TANGLES' PIN PARTS

TPP-1030

High Power Board – Replaces A-15139

Magnet Driver Board with Safety Fuses for “The Addams Family”

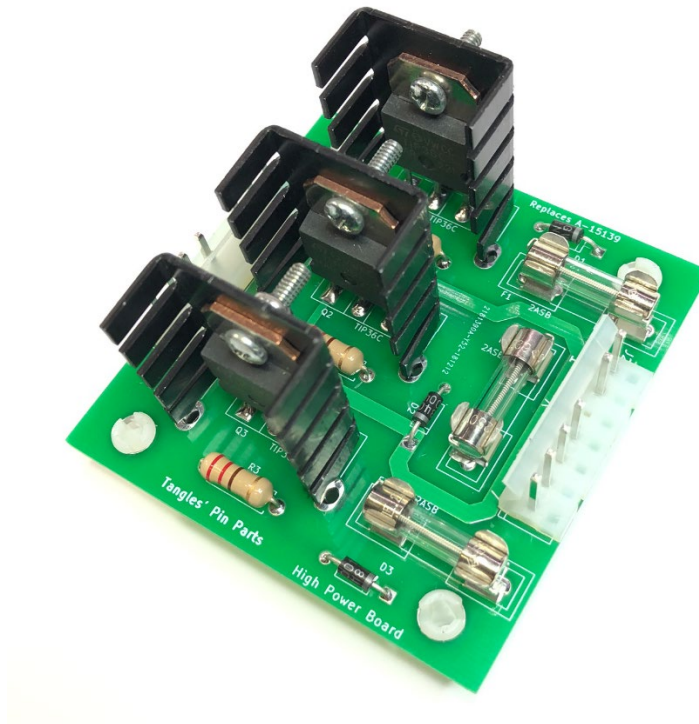
The TPP-1030 board is redesigned replacement for the original A-15139 High power driver. Whilst this board is generically known as a high power driver board, it was used only on The Addams Family machines to drive the three playfield magnets.

The original board has been known to fail locking one or more magnets on. This can lead to a burnt / scorched playfield... ouch!

Whilst there is a 5 AMP fuse in-line with the original board, this fuse is across all three magnets and typically does not blow when there is a single failed driver transistor and one of the magnets is permanently activated.

The recommended fix for this situation is to add individual (smaller valued) fuses to the 3 magnet circuits. This can now be done neatly and easily with this redesigned board featuring 3 on-board fuses.

Installation is a snap, fits original mounting holes and original Molex connectors. Replacement should take only a few minutes.

This board ships with 4 nylon mounts, 3 x 2A fuses installed and 2 spare fuses.
